TRUCK HEAVY MC3 (MACK) - ALL TYPES
ACCELERATOR RETURN SPRING BRACKET

MODIFICATION INSTRUCTION

1. This instruction details the securing of the accelerator return spring by drilling a 6mm hole in the accelerator return spring bracket on the engine, fuel injection pump (FIP).

FIG 1 - HOLE DRILLED IN ACCELERATOR RETURN SPRING BRACKET

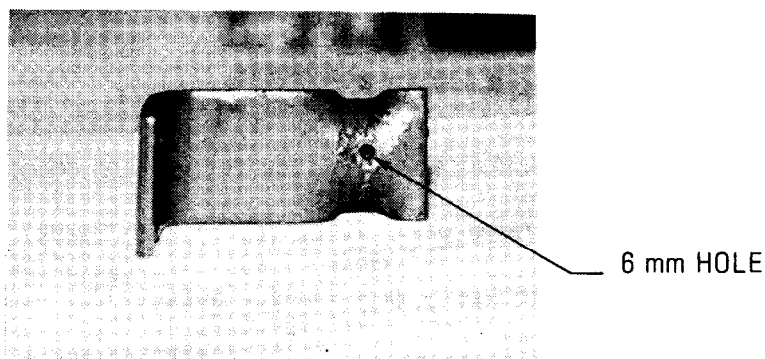
9. Disconnect the accelerator return spring from the mounting bracket on the FIP and remove the bracket.
10. Drill a 6mm hole in the accelerator return spring bracket as shown in Fig 1.

FIG 2 - ACCELERATOR RETURN SPRING FITTED CORRECTLY TO BRACKET

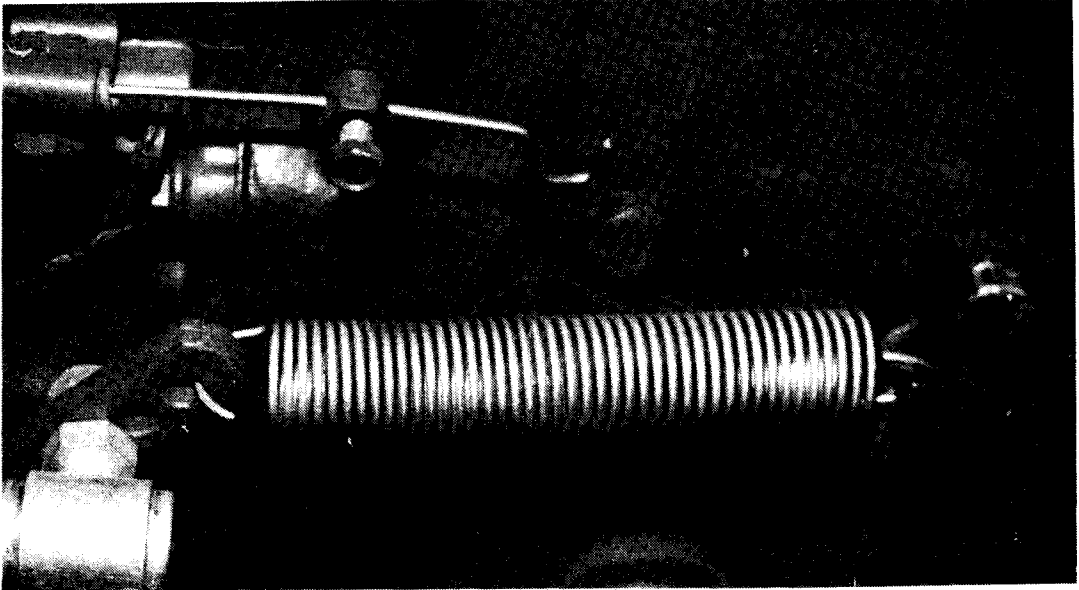
11. Refit the accelerator return spring bracket to the FIP and connect the accelerator return spring by reverse feeding it through the bracket as shown in Fig 2.
